**Location:** Body Exterior - Exterior Ornamentation

**Topic:** Rear bumper exhaust heatshield coming loose

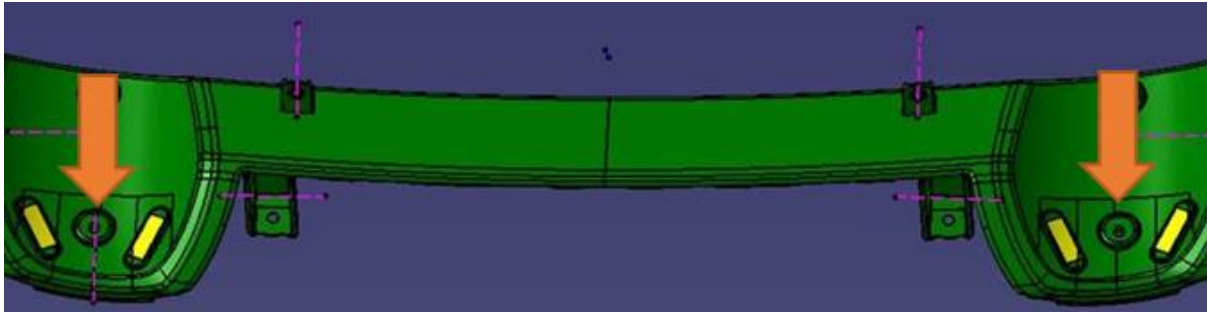
On early production 720S vehicles, the exhaust heatshield on the rear bumper may come lose.

This is due to the adhesive used to install this part to the bumper not being appropriate for this application (high temperature).

This document explains how to repair this concern with new parts and installation method.

A new design of the exhaust heatshield has now been introduced. The new heatshield now has 2 studs an inner and an outer one to secure it on the rear bumper extension.
